S U B M I S S I O N : D O R S E N

a written submission by way of further objection to DA 2019/1522

Re: 41-43 Beach Road Collaroy NSW 2097
DA 2019/1522

WRITTEN SUBMISSION: LETTER OF OBJECTION
Submission #3: Dorsen

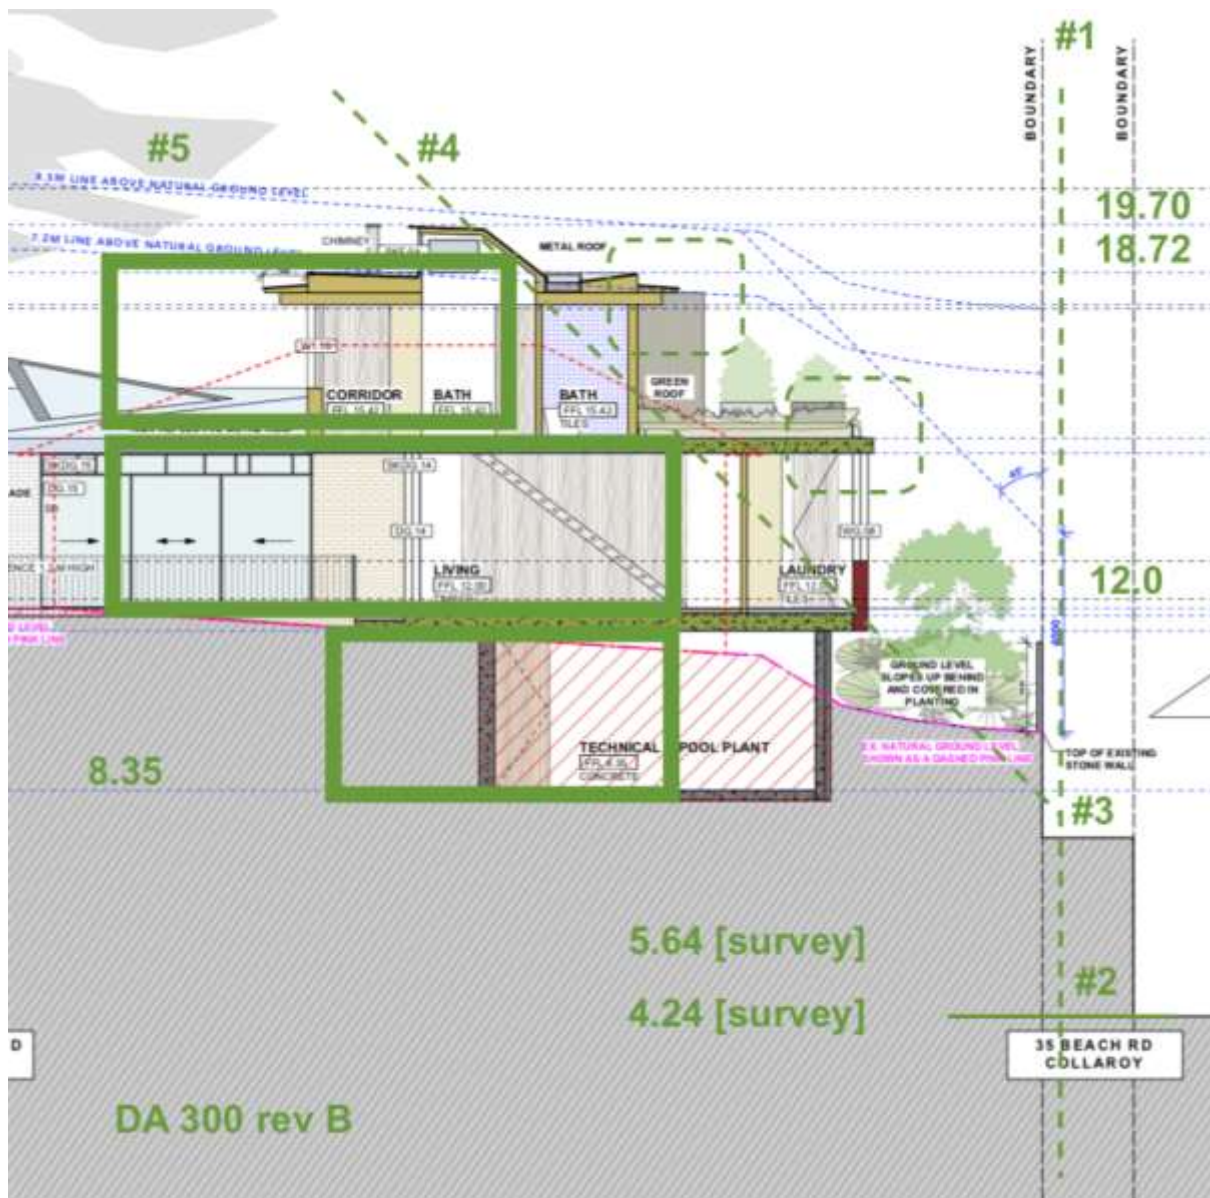
Unfortunately, the DA has once again submitted a series of incorrect drawings in relation to the existing levels along the southern boundary of the subject site.

Council has inspected my property in close detail, and Council clearly observed that the boundary runs along a grass zone approximately 400mm to the south of the large sandstone wall.

Council was very clear in the inspection that they fully understood the levels on the DA's survey along the southern boundary as **RL 4.24 and RL 5.64** as shown on the DA's survey.

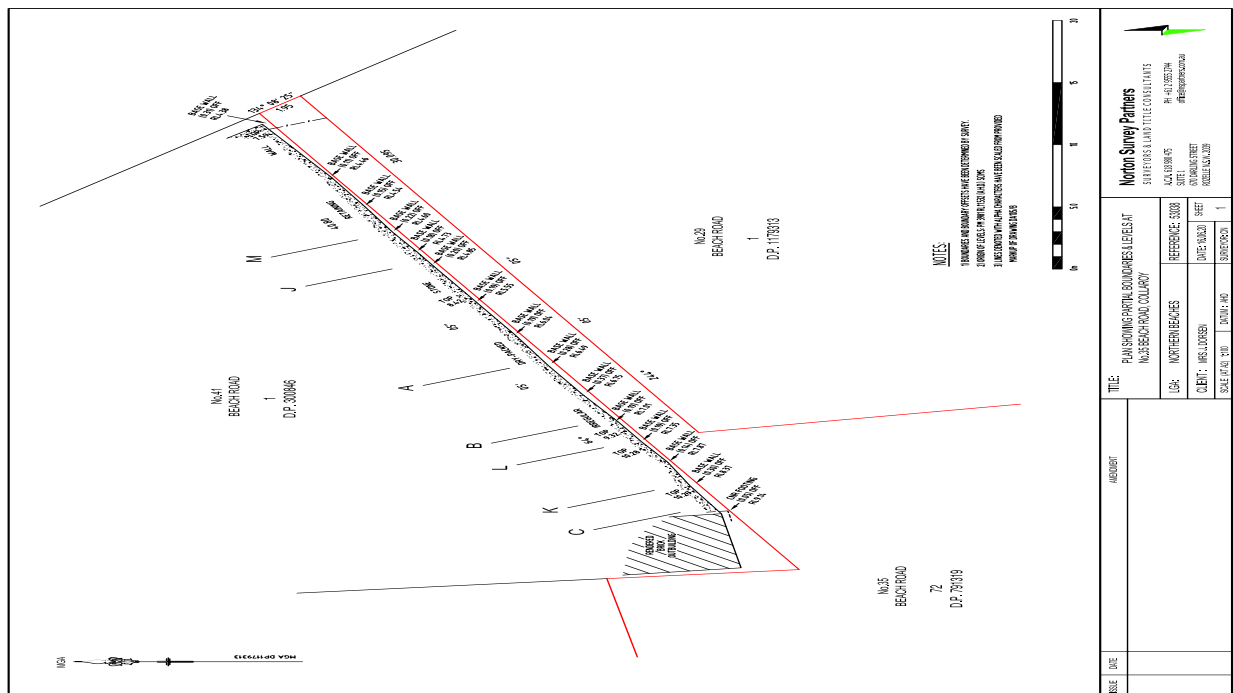
Incorrect Drawings: [my entries in 'green'] Envelope needs considerable further setback to be made compliant. The level of the southern boundary is at #2.

On 9 June 2020, I commissioned a well-respected firm of Registered Surveyors, Norton Survey Partners [Norton], to seek clarification of the common boundary of the subject site.

I choose to undertake this exercise to ensure myself that the Applicants Survey carried out by LTS dated 3 October 2018 reference 50485 001 DT, was accurate in terms of the precise common boundary alignment and level.

The LTS Survey shows levels either side of these positions at **RL 4.24 and RL 5.64**.
Extrapolating between the LTS survey levels, gives similar RL levels as the Norton survey.

DA 500 A: Unreasonable overshadowing as a direct result of non-compliant built envelope

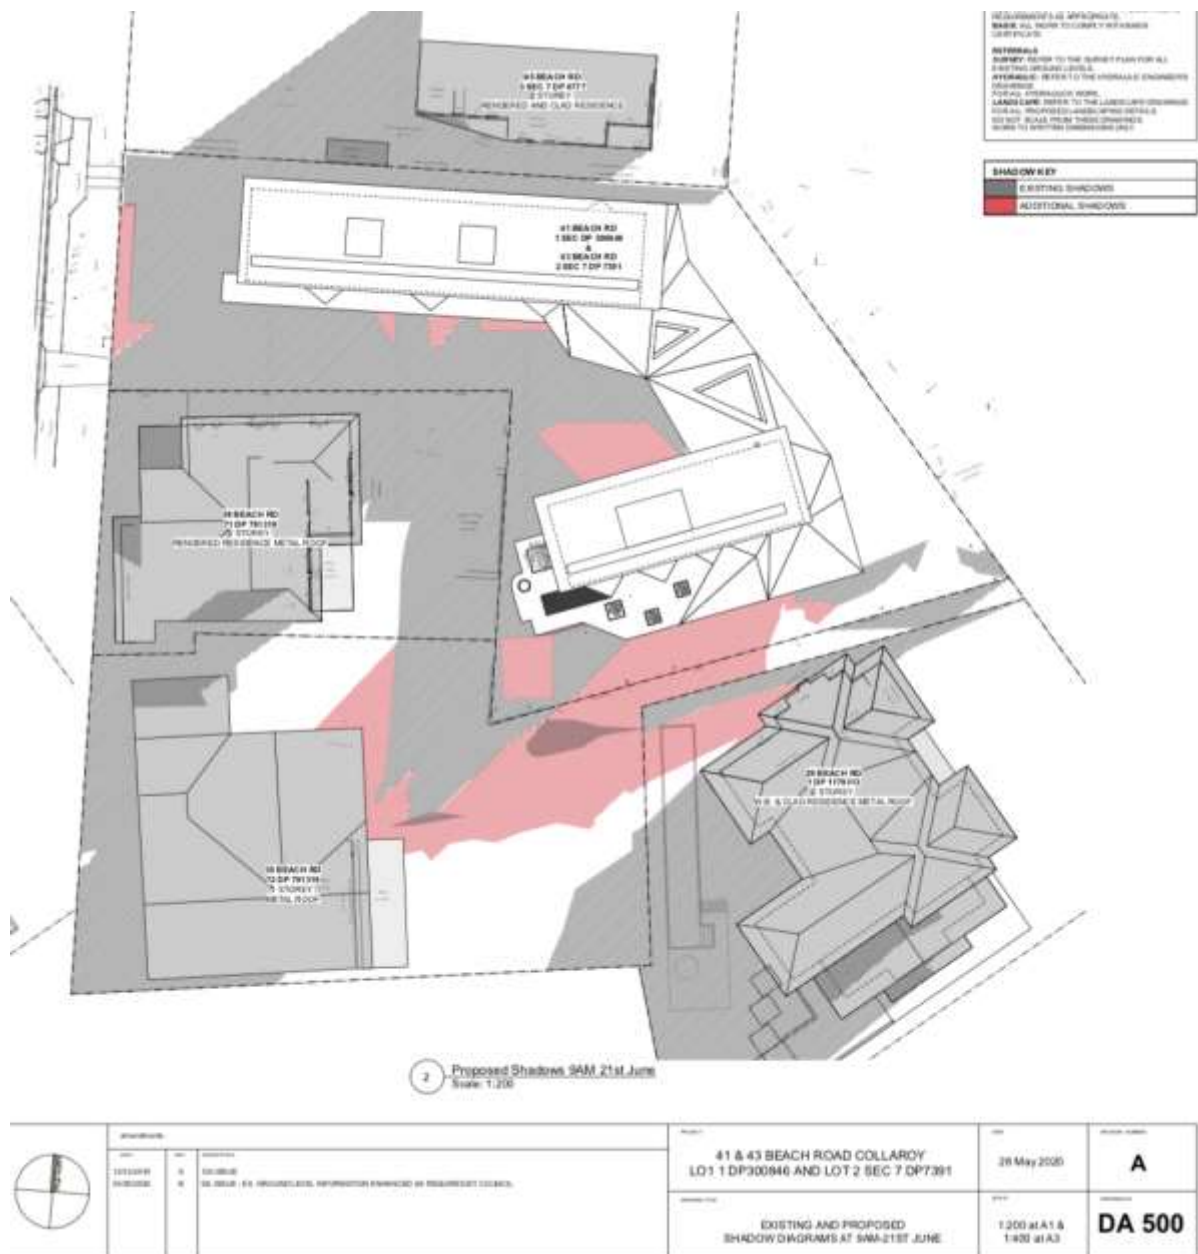
The solar access into my property is highly compromised, and the loss is totally as a result of the non-compliance to **DCP B3 Side Boundary Envelope** controls. The loss of morning

sunshine onto my house by this unreasonable envelope is totally unacceptable. The loss extends to my private open space lawn zones throughout the day. The difference between a compliant envelope and this non-compliant envelope has not been assessed.

I contend that the DA can avoid the impact by repositioning the southern wing to be maintained within the **DCP B3 Side Boundary Envelope**. A more sensitive design to accord with these controls would achieve the same amenity whilst reducing the impact. The DA has not assessed the difference between a compliant B3 Side Boundary Envelope and the non-compliant envelope in this set of amended plans.

My property and windows remains unsurveyed by the DA, so the diagrams provided are guesswork.

The proposed development does not ensure that reasonable access to sunlight is maintained. The non-compliant development is causing considerable solar loss, and my property has not even been surveyed, let alone shadow diagrams completed.

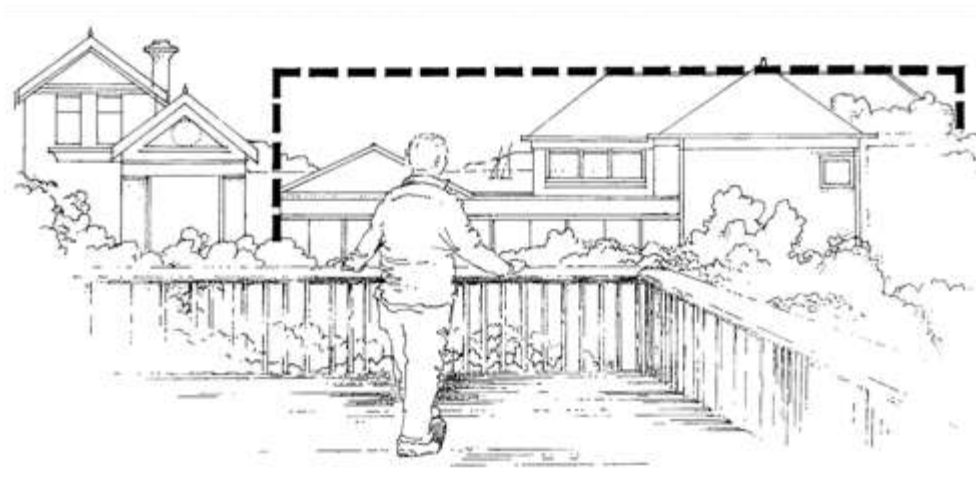
As the proposed development does not comply with outcomes and controls, that are the most relevant to visual impacts, greater weight would be attributed to the effects caused.

In my opinion the extent of view loss considered to be greater than moderate, in relation to the views from my living rooms and living room deck of my dwelling, particularly to the north and east towards the water view.

The view is from a location from which it would be reasonable to expect that the existing view, could be retained especially in the context of a development that does not comply with outcomes and controls.

Where there is a potential view loss, Council should require a maximum building height of less than 8m for part of the building, and should consider other modifications to the design to achieve view sharing.

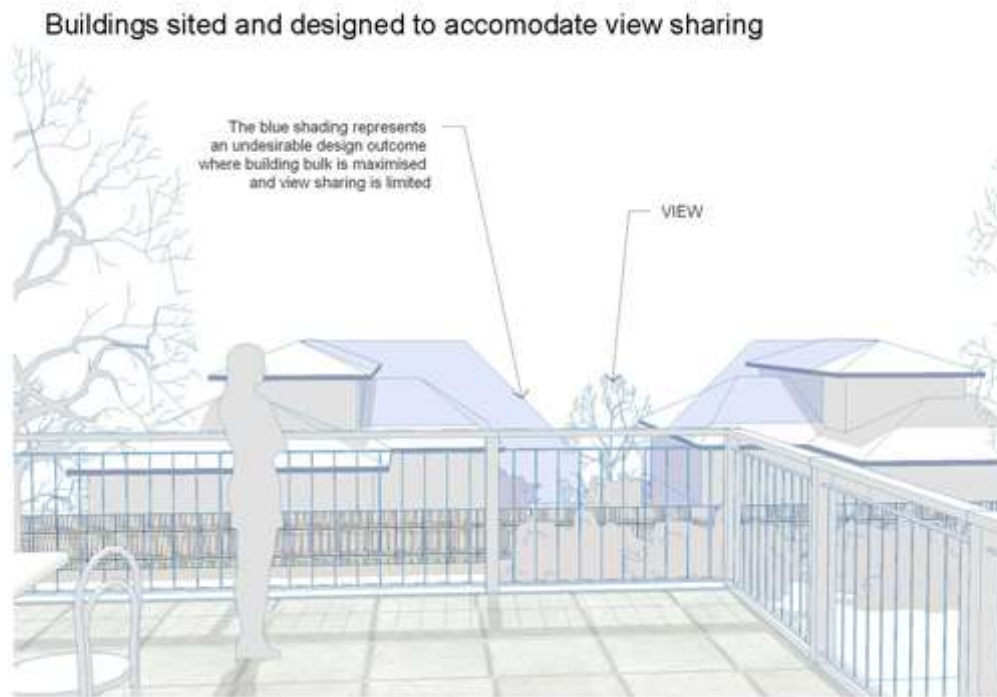
The DA should have informed the design by a complete view loss consideration that would have clearly identified that any development extending to the north on the subject site, within the side envelope controls, would remove my view.

At this juncture, the proposed development cannot be supported on view loss grounds.

The proposed development is over maximum building height, and grossly exceeds side boundary controls, over most of the southern wing of the proposed development.
